# FIRE SAFETY INSPECTION REPORT

**Factory Name: New Asia Fashions Ltd.**

**Date: 18th September, 2017**

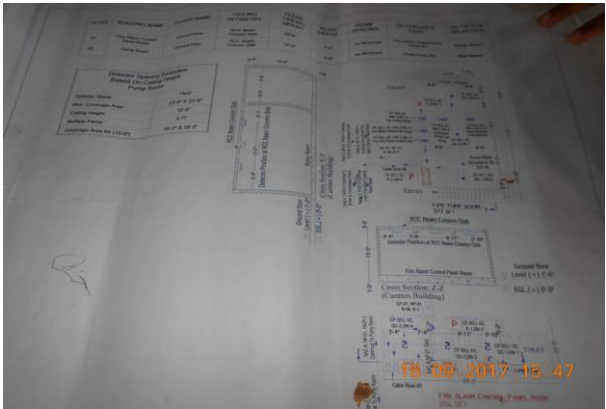
11	Egress	Handrails are not provided on both sides of each exit stairs on all floors. Having handrails on one side of said staircase, may pose as a falling hazard during evacuation.	Provide handrails on both sides of the exit stair. New handrails shall have a minimum height of 865 mm (34 in.) and a maximum height of 965 mm (38 in.) as measured from the leading edge of the tread. Intermediate handrails shall be provided when the stair width exceeds 2.2 m (87 in.).	Within 3 months
